**Town of Waterford
Board of Selectmen**

**Bid #10-112
ADDENDUM #2
January 22, 2010**

COMMUNITY SERVICES BUILDING

WATERFORD MUNICIPAL BUILDINGS
WATERFORD, CONNECTICUT

EXTERIOR ELEVATIONS

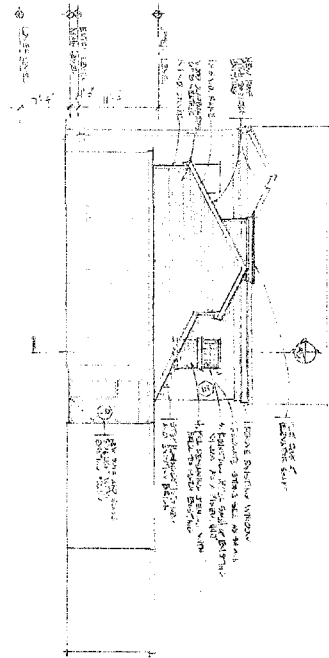
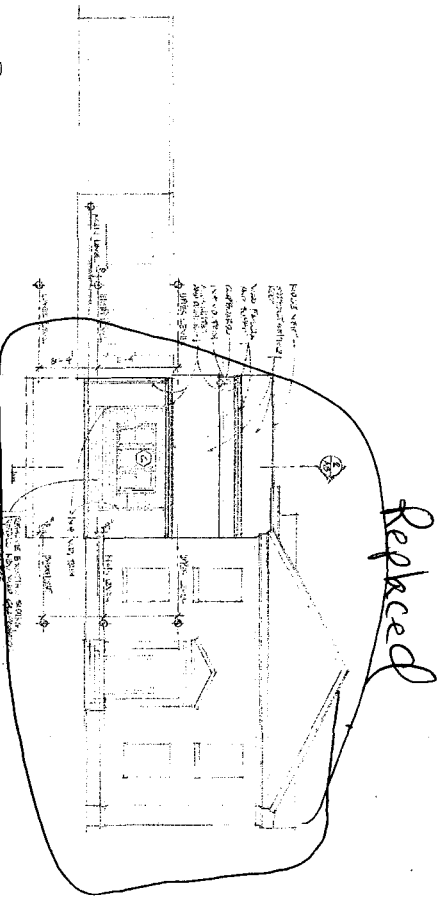
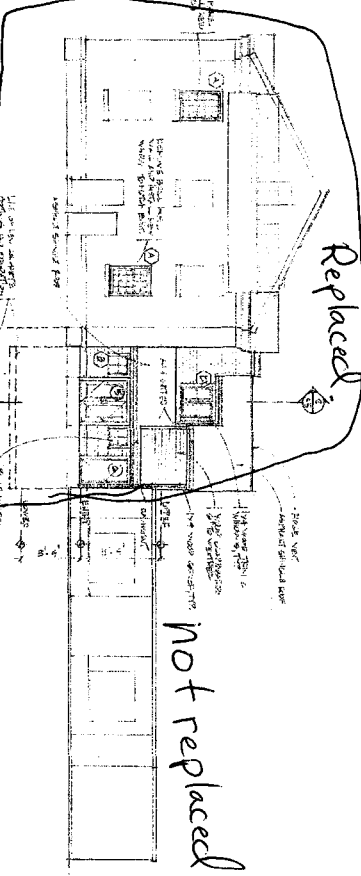
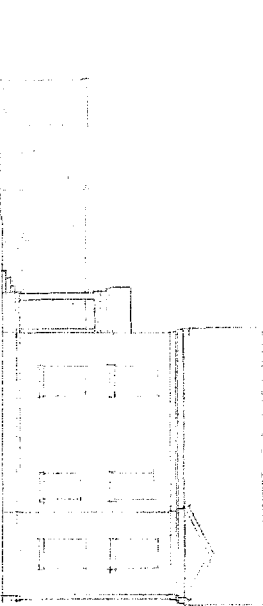
1. **Question:** Is the re-roofing strictly limited to the existing slate roof with the existing asphalt shingle roof to remain?
Answer: NO, The re-roofing project includes the asphalt shingled roofs. Please see attached drawing.
